<b>Safety and Airspace Regulation Group</b>	<b>DAP 1C</b>
Doc Type:	Annex C	Version: 1/2012
Title:	<b>Airspace Change Proposal Operational Assessment</b>	Page 1 of 29

<b>Title of Airspace Change Proposal</b>	<b>SOUTH COAST CHANGES – Module E of LAMP Phase 1a ACP</b>
<b>Change Sponsor</b>	<b>NATS (NERL)</b>
<b>SARG Project Leader</b>	<b>[REDACTED]</b>

<b>Case Study commencement date</b>	Issue 1 Received 17 February 2015. Commenced Case Study 4 March 2015 Issue 2 Received 20 March 2015
<b>Case Study report as at</b>	27 July 2015 – Version 1.1; updated 10 Sep 15 as Version 1.2

TODAY (ignore FL65 base in IOW area)  
Everything converges at GWC and SFD

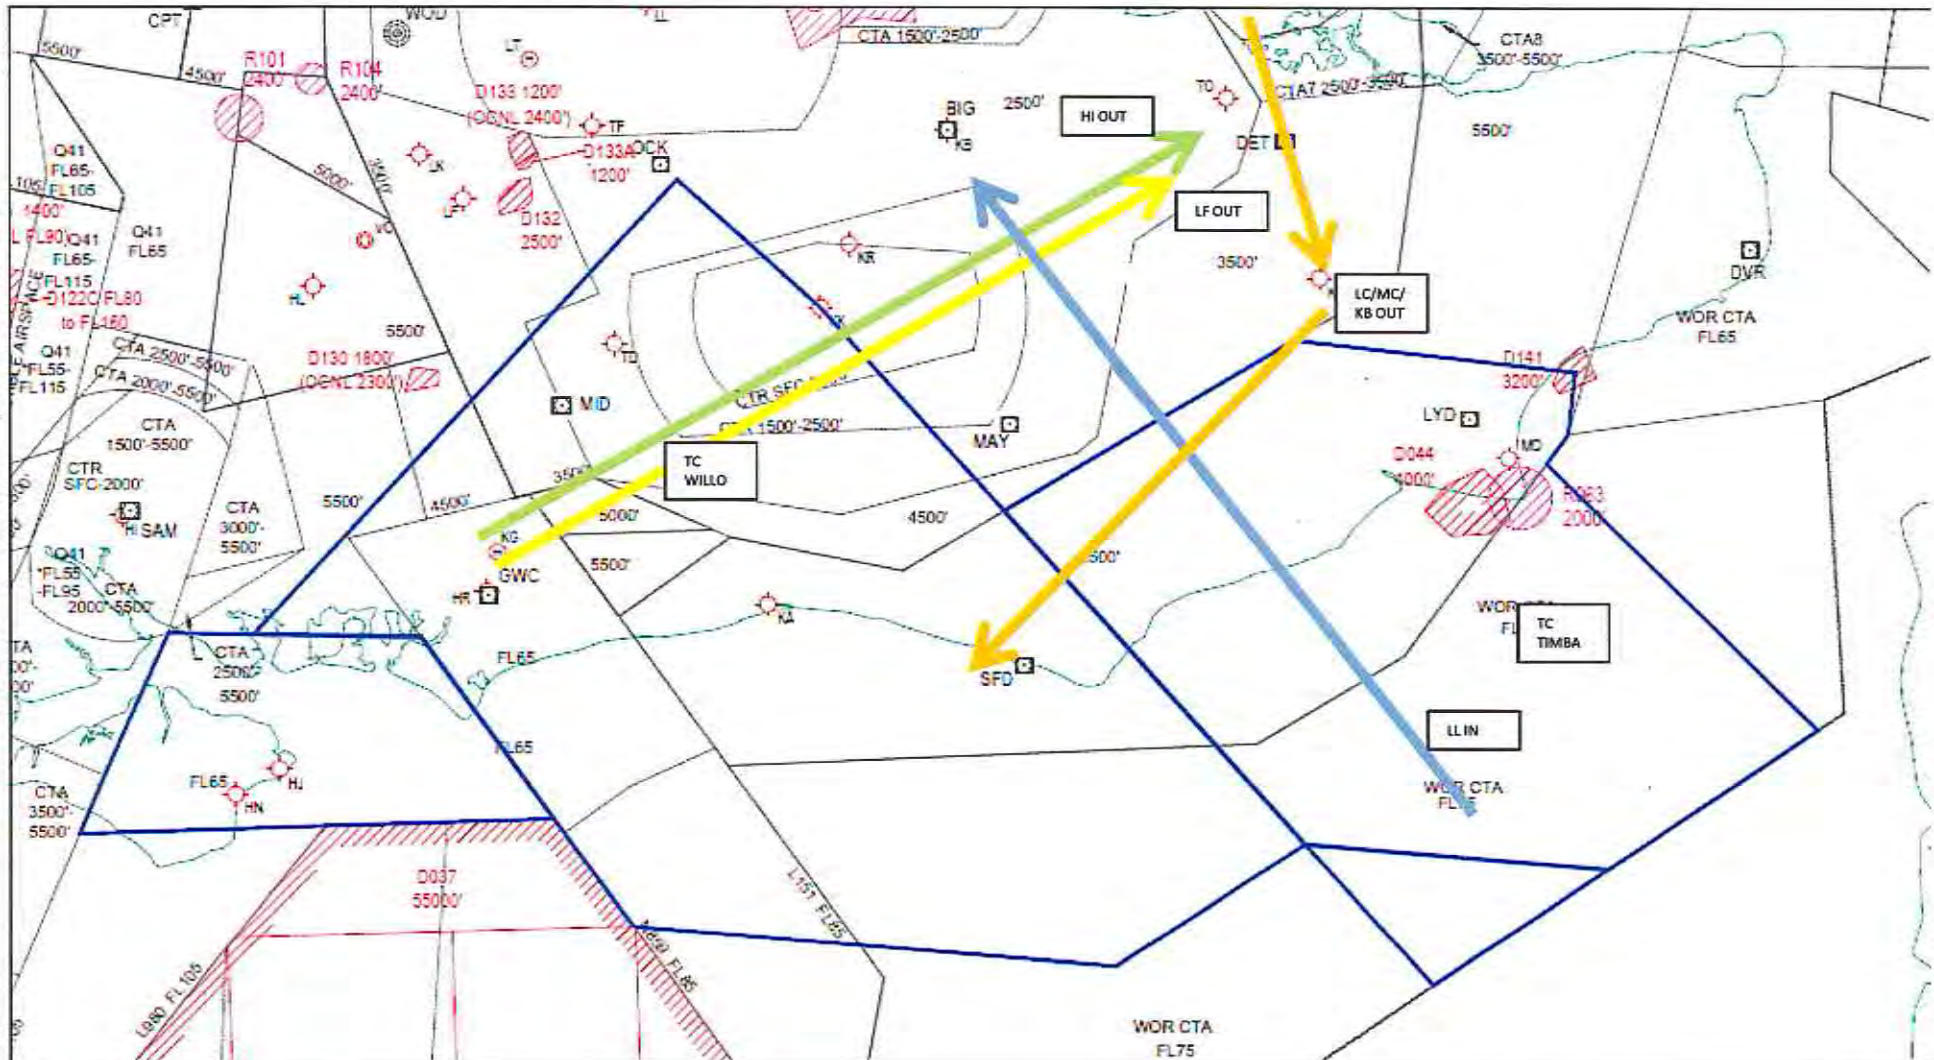
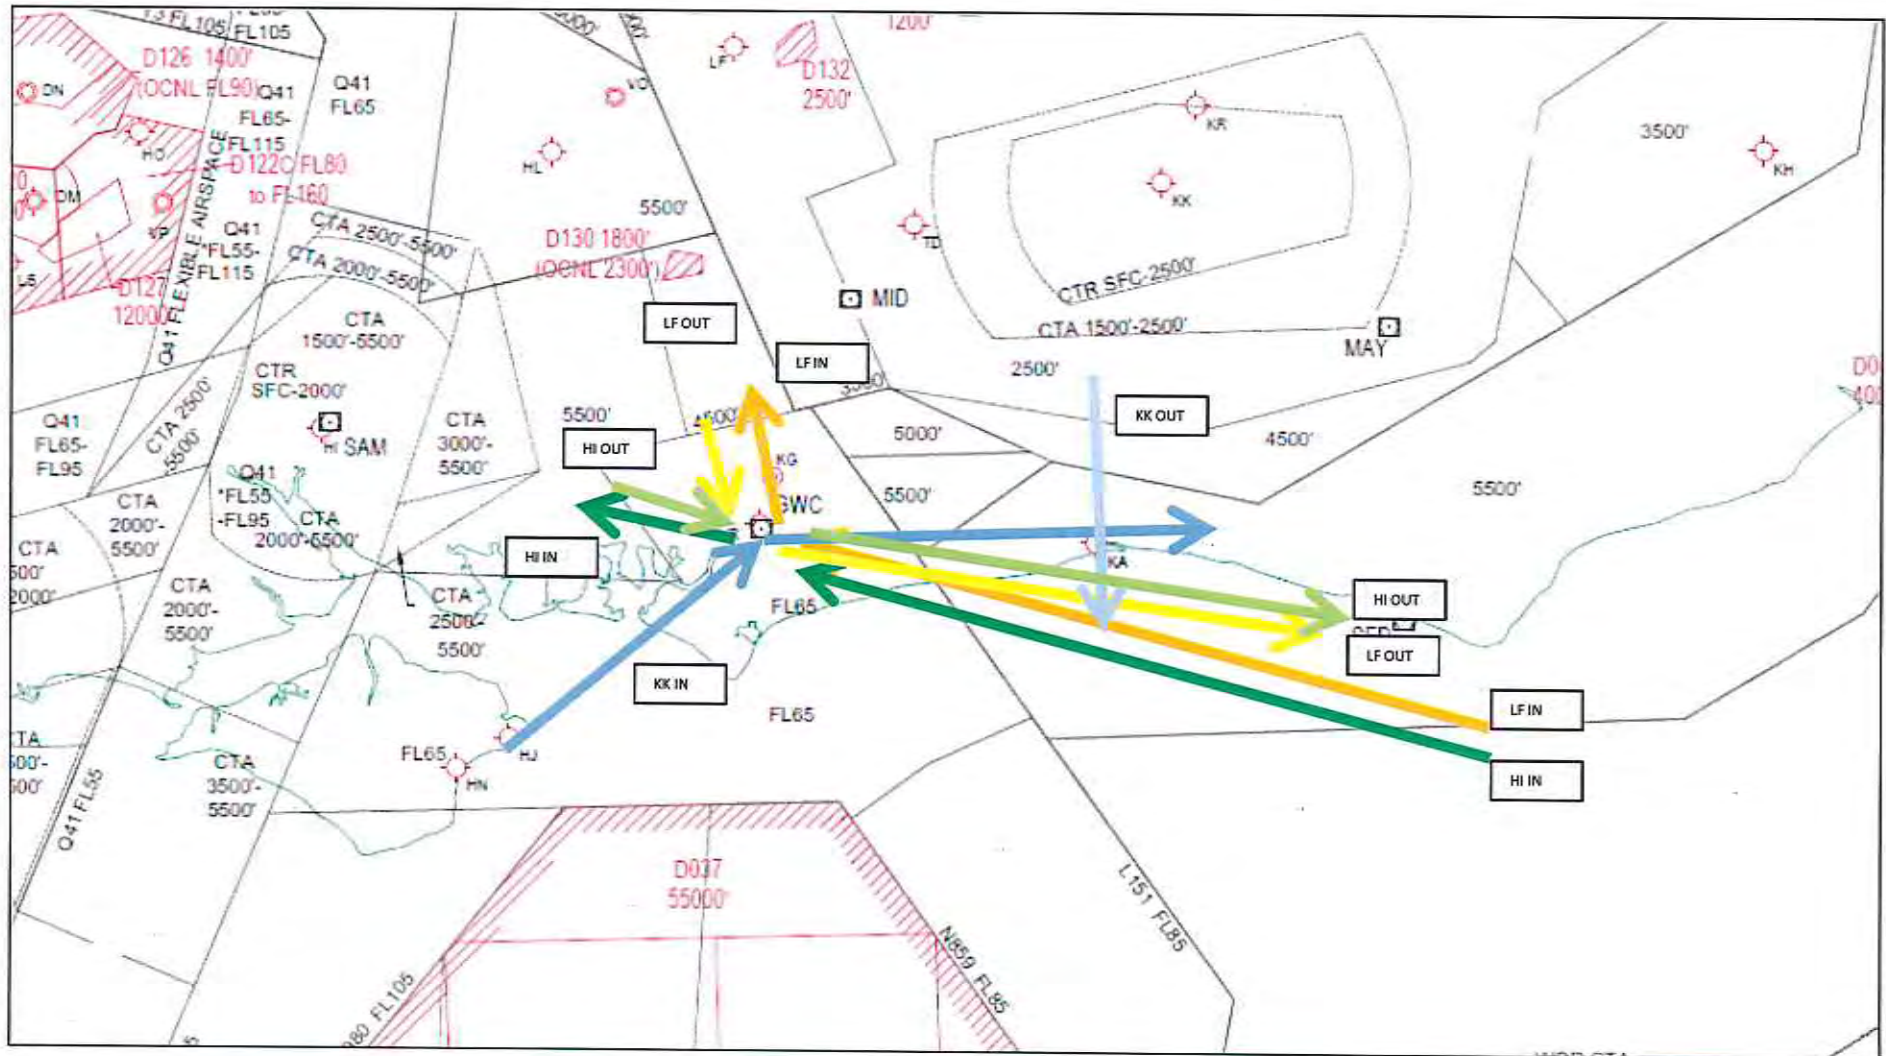
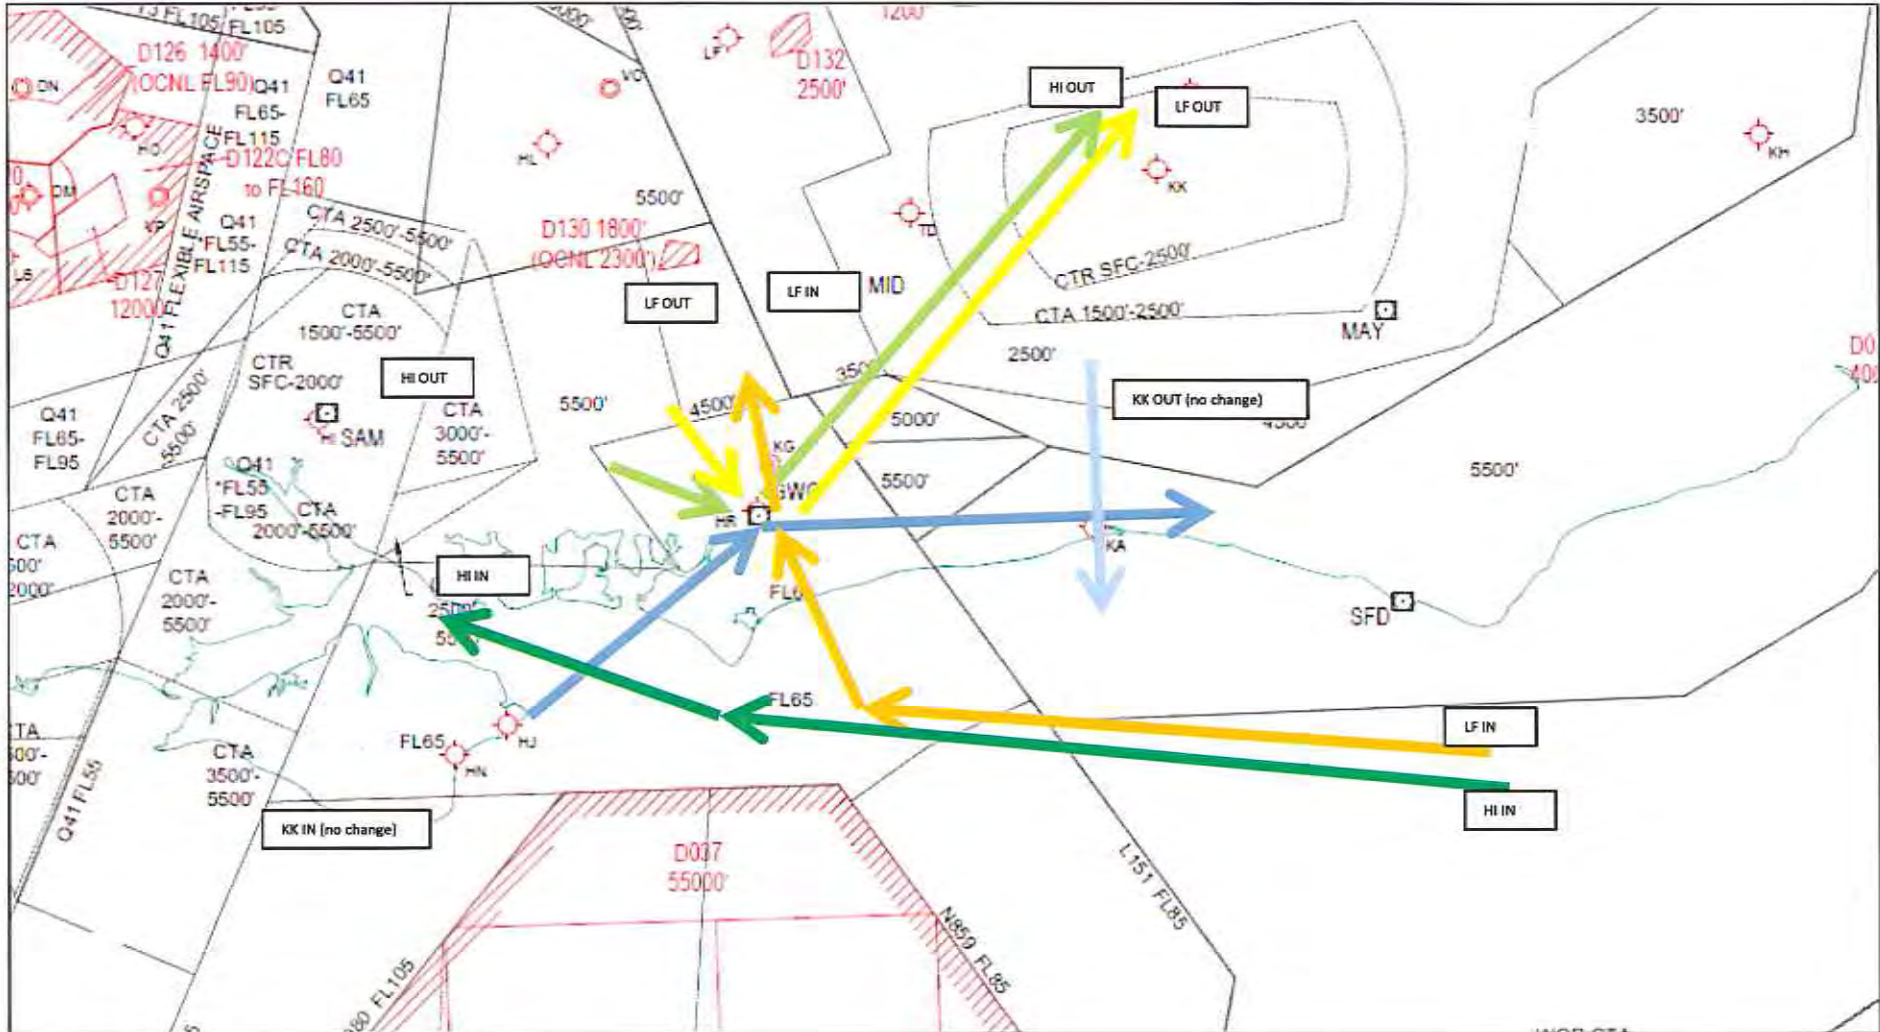
**Today.** TC Sth boundary in Red. LF and HI Deps climb from TC WILLO to S18 9not shown). S18 climb to FL190 and give to S17 (not shown) who then generally jump the LL arrivals by vectoring north of track (dashed green/yellow lines) to get away from the LL arrivals as their profiles are the same where their flight planned routes cross . These LF and HI departures outclimb the LC/MC/KB deps via LYD which have been held down low for miles by Thames. This is currently all S17's job. The LF/HH and HI avoid TC TIMBA. The LF/HH and HI avoid TC TIMBA.

**LAMP 1a.** TC Sth boundary in blue. TC TIMBA much bigger and taking on chunk of S17 task. The new LC design gets LC arrivals higher, quicker allowing TC TIMBA to cut them across ahead of LL arrivals. This would put them head on to LF/HI/HH deps if left via SFD as today: both reaching the SFD/MAY area at the same height.

If we left the LF/HI/HH deps as today they would therefore have to be held down low, underneath LL arrivals and be as low as FL190 as they approach DVR (rather than at cruise). Not only is this restrictive in terms of levels and penalising in terms of fuel and CO2, it would also add complexity to the enlarged TIMBA sector that is disproportionate to the average of c.7 LF/HI/HH flights a day as they would be perpendicular to the primary LL arrival flow through the sector, and seeking climb. Note also that c.7 per day is an average number – the complexity would increase on days when there are more flights and/or when they happen to be during times that TC TIMBA is already busy.

Helps to de-conflict all these routes in TC WILLO

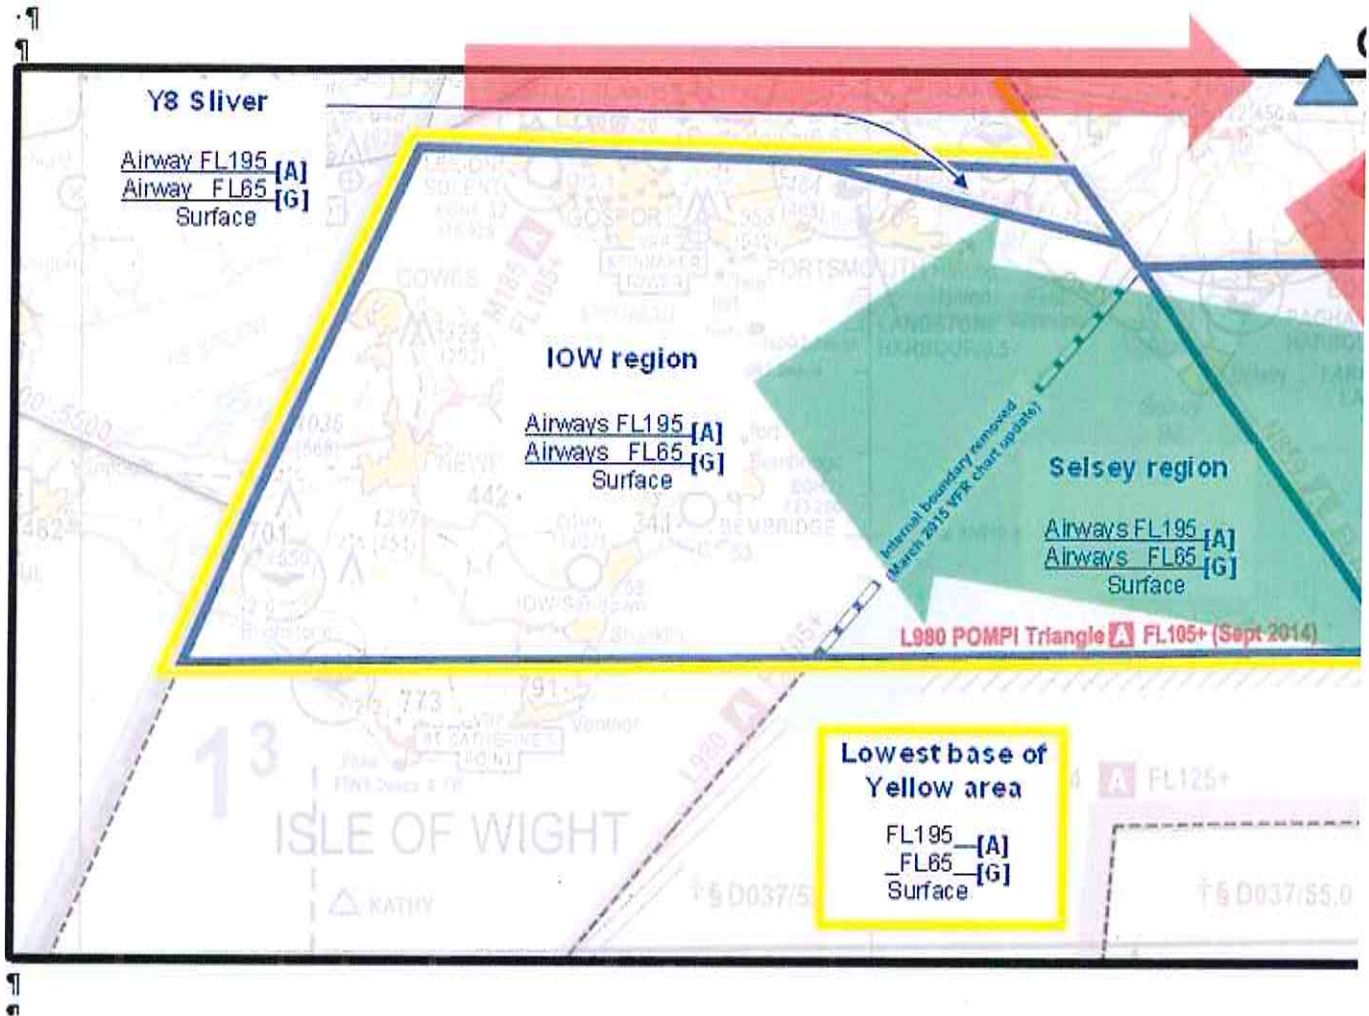
"The Figure below shows the path of the Solent arrivals on the proposed STAR (green arrow) and the existing Solent departures to the south via GWC (red arrow). The Solent departures flight plan to GWC to exit UK airspace at SITIT, XAMAB or XIDIL, all of which need level separation with the inbound flows. This interaction will be managed tactically by descending the arrivals to FL70 while the departures are climbed to FL80 before turning south.

The justification for the proposed dimensions and base is therefore to provide sufficient airspace to cross the Solent arrivals beneath the departures. "

Why not climb leave arrivals at FL90 and climb Solent deps to FL100 for the cross?

Solent currently climb the departures via GWC to FL70. We are increasing this to enable them to get the level change on the Solent arrivals. We can't give Solent FL100 on all their departures because:

It would also cause some potential safety issues with opposite direction traffic crossing vertically whilst under the control of different units (solent and TC). This is rather complicated to explain – if you need more justification that described above let me know and we can get you more detail on this issue.
